METROPOLITAN GOVERNMENT OF NASHVILLE AND DAVIDSON COUNTY

STAFF RECOMMENDATION
1009 North Sixteenth Street
August 21, 2019

Application: New Construction—Addition
District: Eastwood Neighborhood Conservation Zoning Overlay
Council District: 7
Base Zoning: R6
Map and Parcel Number: 08302014800
Applicant: Hunter Conley, Allard Ward Architects
Project Lead: Paul Hoffman; paul.hoffman@nashville.gov

Figure 2: Footprint in 1957 shows the rear porch not yet enclosed.

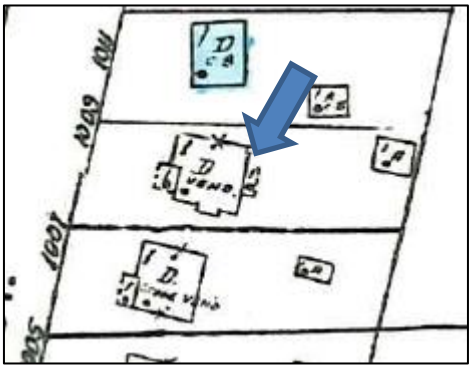
Demolition: An enclosed rear porch and existing rear addition on the house, approximately one hundred and sixty-five square feet (165 sq. ft.) in area, will be removed for the new addition.
The existing rear addition was an original porch enclosed after 1957 (Figure 2) and does not contribute to the architectural and historical character and significance of the building due to the changes and its minimally-visible location.

Staff finds that the partial demolition meets Sections III.B.1 and III.B.2 for appropriate demolition.
